Title: Space Renovation and Reconfiguration Support TWFN 4th Floor Demolition Project

4TH FLOOR
REFLECTED CEILING
DEMOLITION PLAN

Addendum No. 2, General Contractor site walk thru and meeting of 05/06/2014 and Contractor questions; Addendum 2 Drawings issued on 05/08/2014:

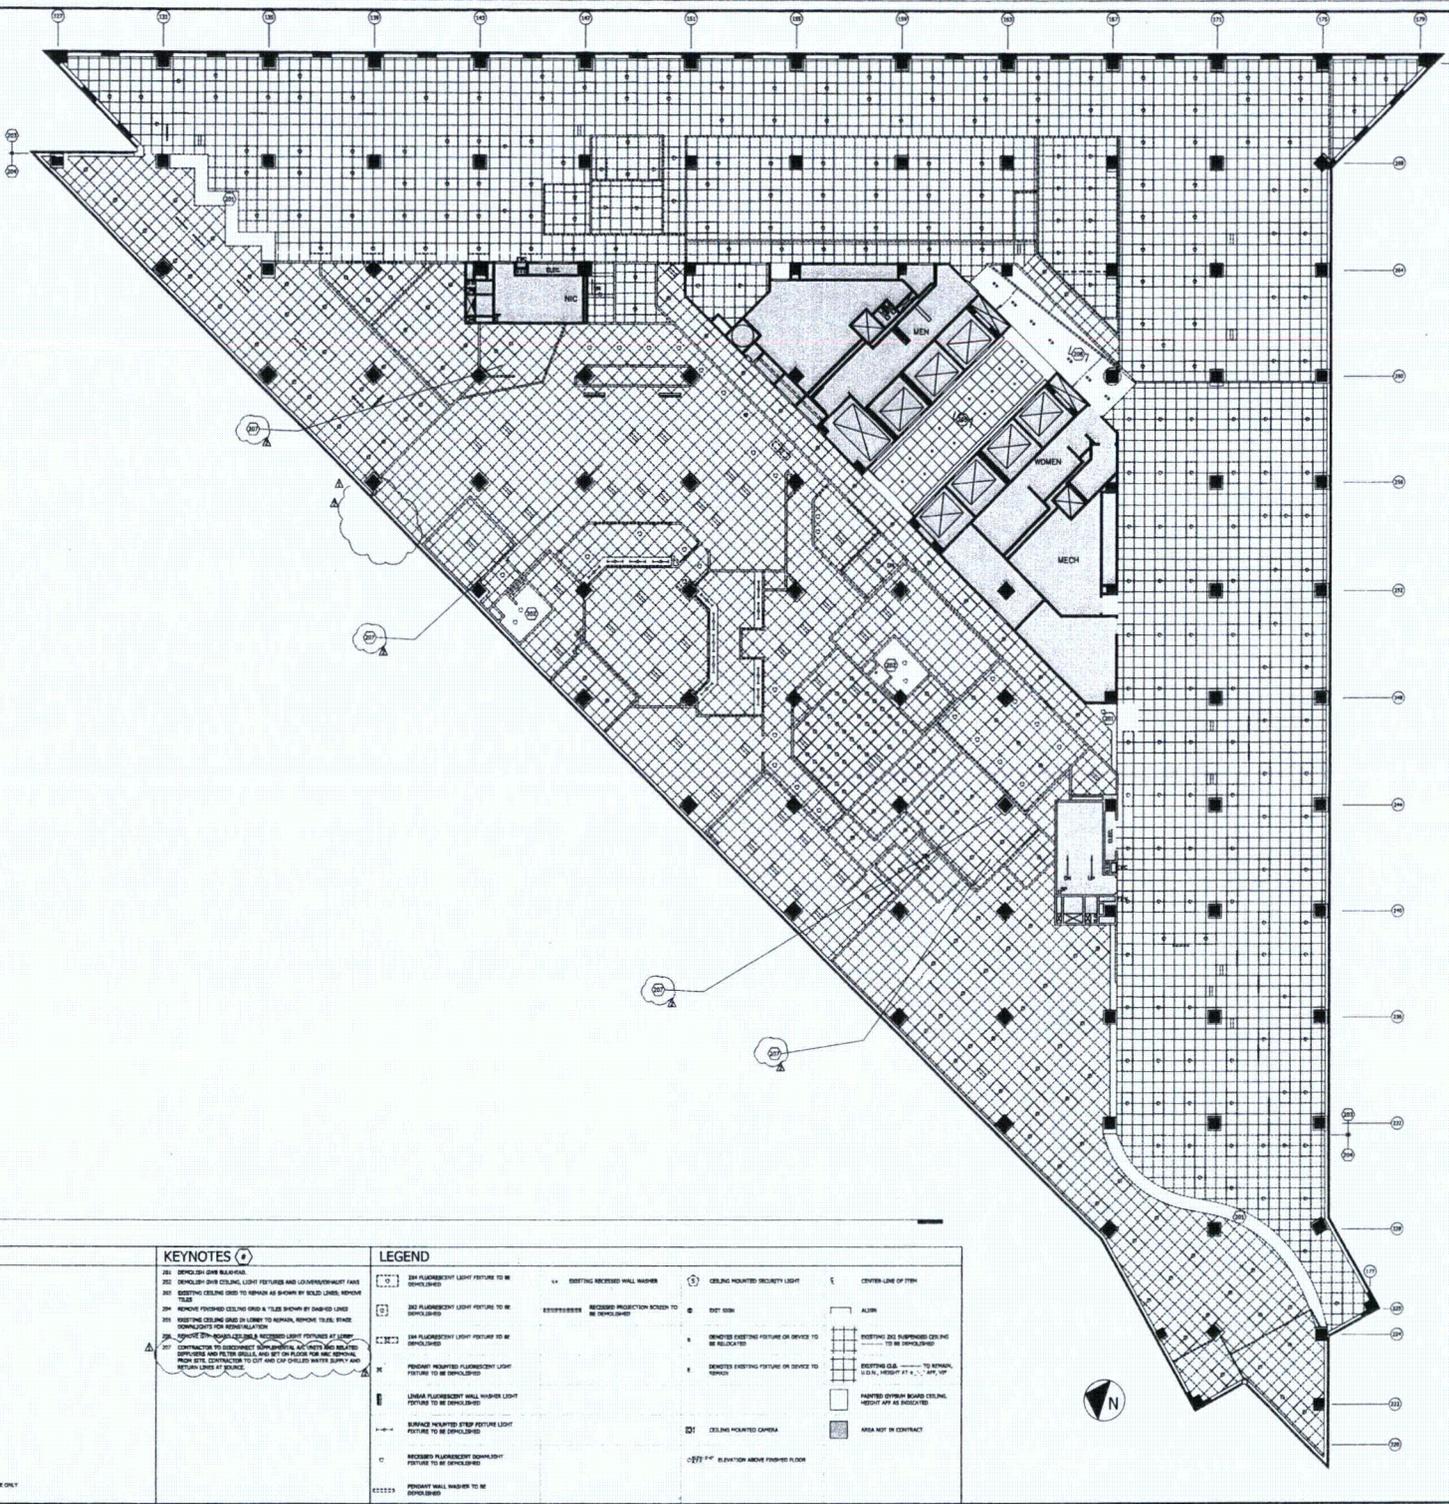
- c. Key note 105 indicated on Demolition Plan at Col. No. 163-268 (Former SCIF room)
2. Sheet A2.0:
 - a. General Plan Notes, Note 1: Secure all fire alarm devices and light fixtures to remain; coordinate any demolition of fire alarm devices with Simplex.

- b. General Plan Notes, Note 5: Do not remove or damage new communication wire (yellow) that has been run to VAV boxes; consult with NRC Facilities Management Branch to ensure wires are not disturbed or damaged.

- c. General Plan Notes, Note 6: protect all existing thermostat wiring, secure all fire alarm devices and light fixtures to remain.
 - d. General Plan Notes – Note 13, Add / Alt #1 – sequence change only, note remains unchanged.

- e. Key Notes, Note 207: Remove existing Liebert units from above ceiling and set on floor; KKT will remove and store for reuse. Cut and cap chilled water supply and return lines at source. Key note 105 indicated on Reflected Ceiling Demolition Plan in the general area of the abandoned OPS center

- h. Demolition Plan: Demountable partitions are removed from this plan.
2. Sheet A2.0:
 - a. General Plan Notes: Add to Note 11: See Reflected Ceiling Demolition Plan and Key Notes.

- b. Key Notes: Change No. 207 to read: Contractor to disconnect ceiling mounted supplemental A/C units and related diffusers and filter grilles, and set on floor for NRC removal from site. Contractor to cut and cap chilled water supply and return lines at source

- c. Reflected Ceiling Demolition Plan: Note 207 added to 4 locations within ops center.
